PLAN COMMISSION

OFFICIAL NOTICE & AGENDA

A meeting of the Town of Rib Mountain Plan Commission will be held on **Wednesday, June 14th, 2017; 6:30 P.M. at 3700 North Mountain Road, Town of Rib Mountain Municipal Center**. The Town Board may attend for purposes of gathering information. Subject matter for consideration and possible action follows:

SHEET TITLE
OVERALL SITE PLAN

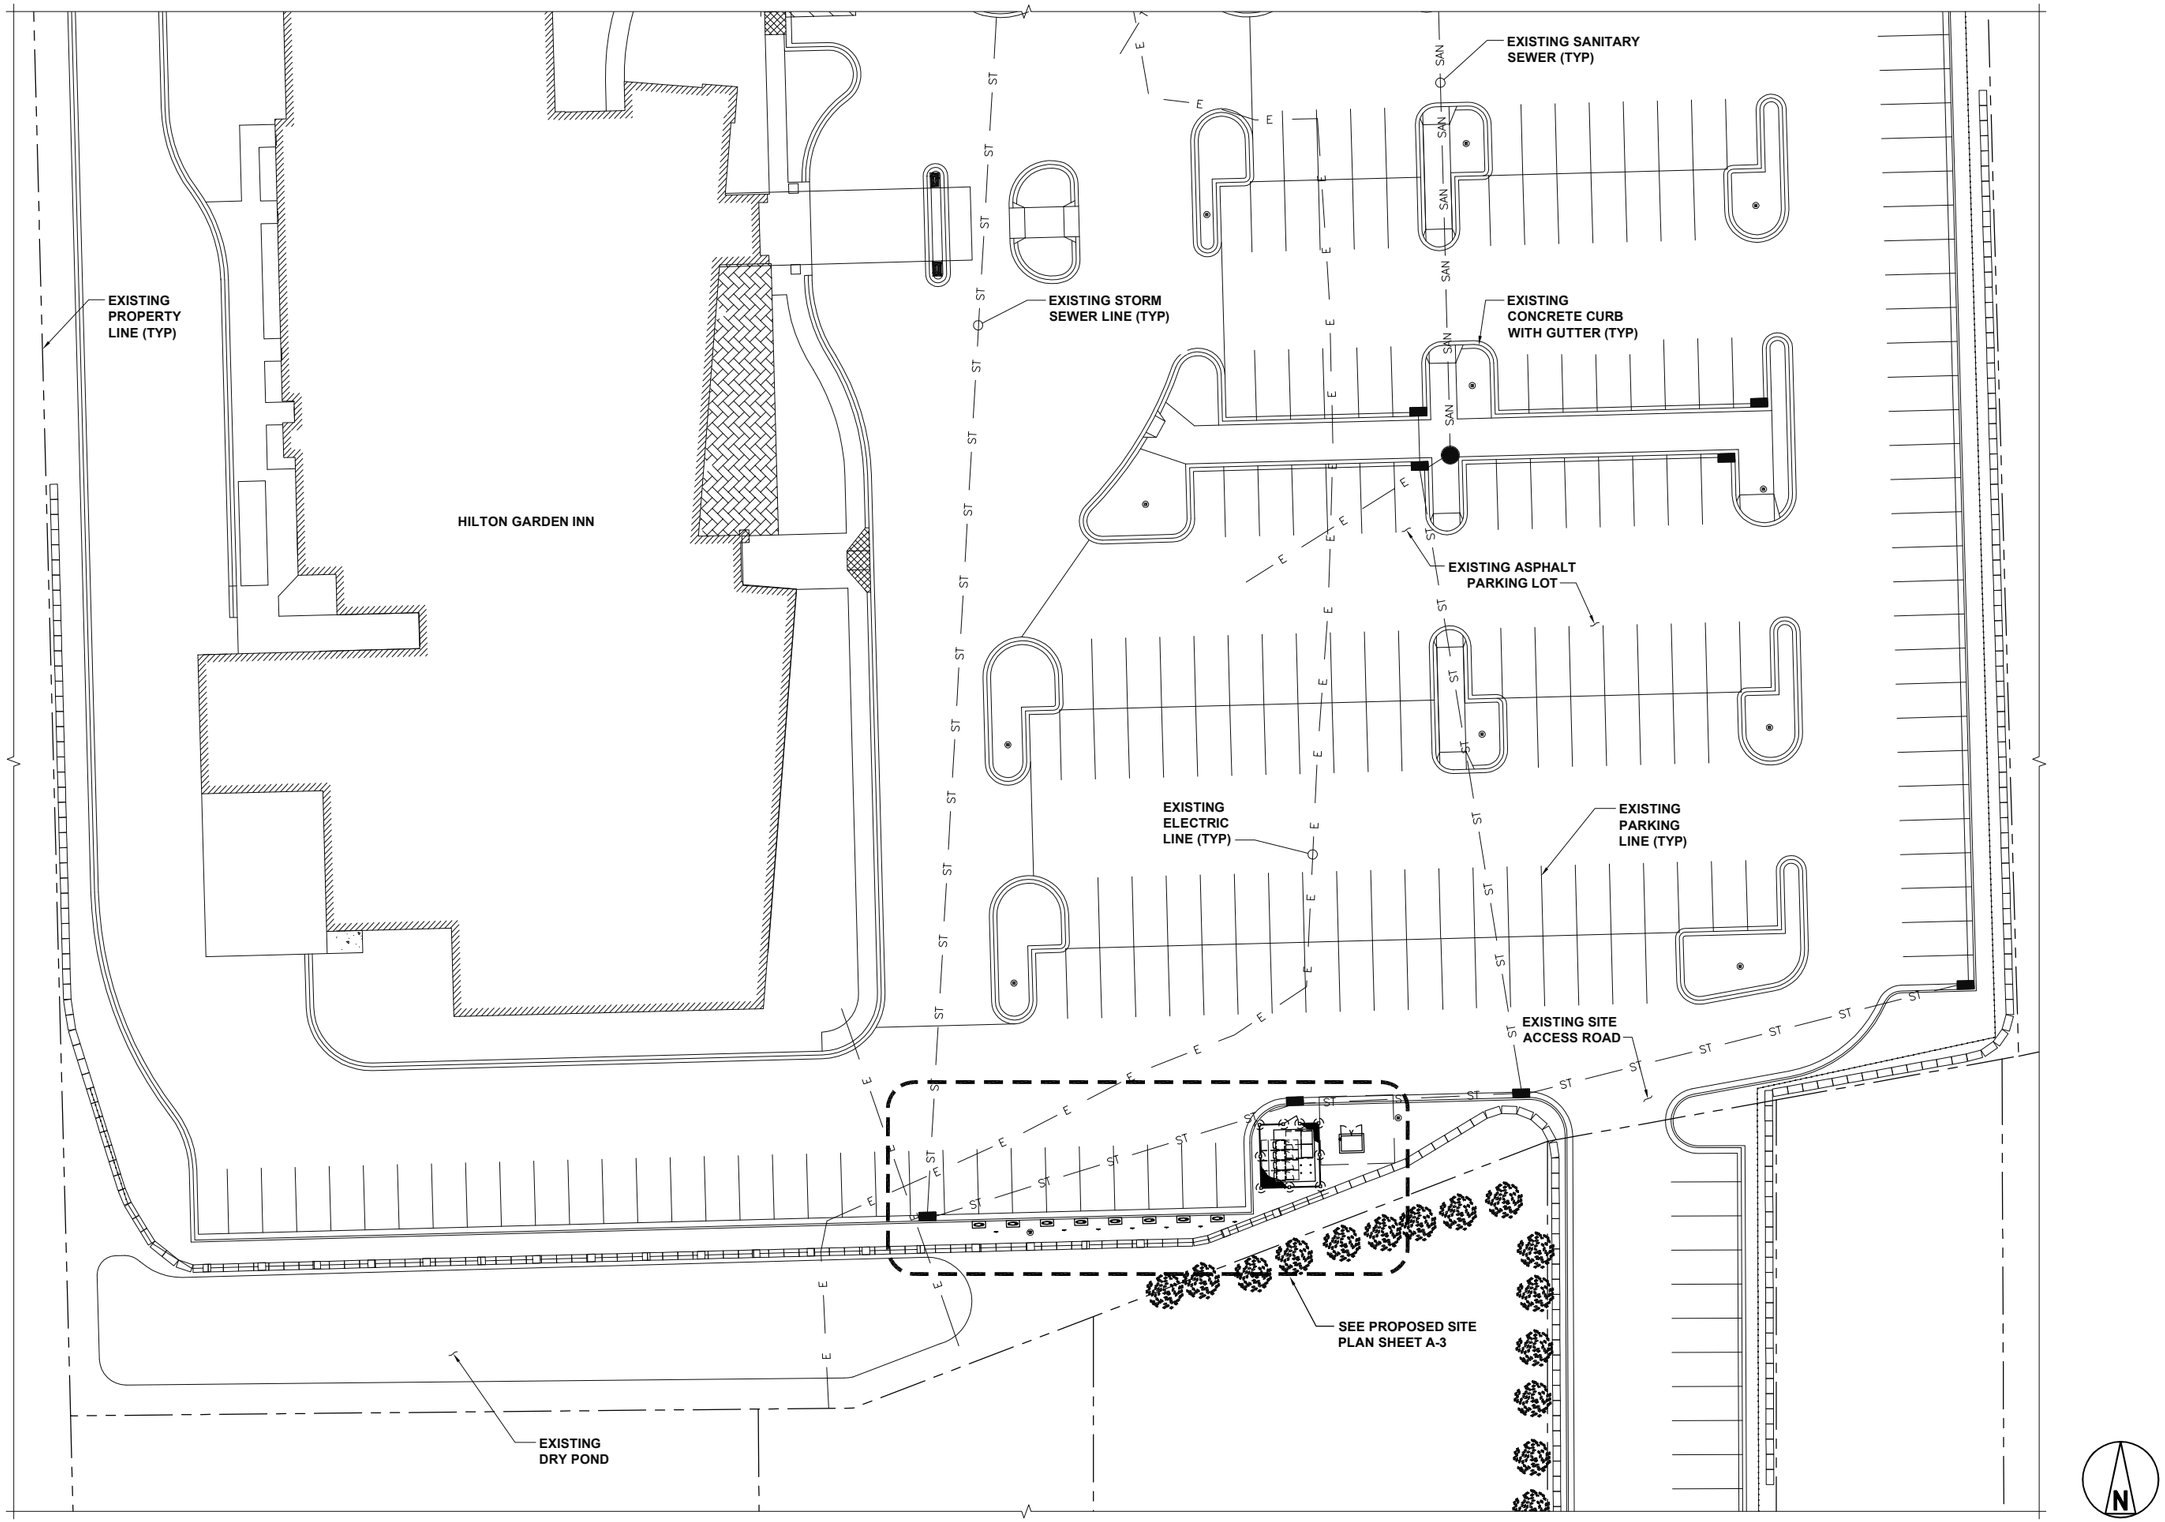
1. Why was the proposed location chosen for the equipment and charging stations (The concern is based on the proximity to the residential housing units and the thought that a location on the north side of the property would allow easier access from the main site entrance and highway accessibility)?

3. What is the anticipated traffic impact to, from, and through the hotel site?

7. Will there be sufficient parking on site with eight spaces designated for charging?
